BYER GEOTECHNICAL, INC.

March 23, 2020

BG 22747

Geologic and Soils Engineering Plan Review and Update
Proposed Lot Line Adjustments and Two Residences
Assessor's Parcel Nos. 5649-021-025 and 5649-008-005, -006, -012, and -013
601 Bohlig Road
Glendale, California

SECTION "A-A"
NOT TO SCALE

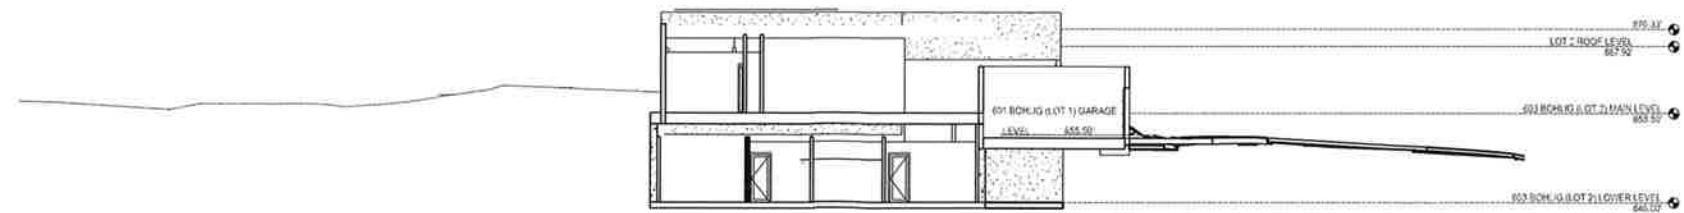
The recommended bearing material is bedrock. Conventional foundations may be used to support portions of the residence provided the footings are adequately setback from descending slopes and from lower retaining walls. Deepened foundations are recommended for portions of the residence on the westerly lot (Lot 2) to ensure embedment in bedrock and achieve the required setback from the steep descending slope. Deepened foundations are also recommended for portions of the residence and pool on the easterly lot (Lot 1) to ensure embedment below a 1:1 plane from the bottom of the subterranean garage. The garage roof should be designed as a structural slab capable of supporting the future backfill (see Section A Sheet C-3).
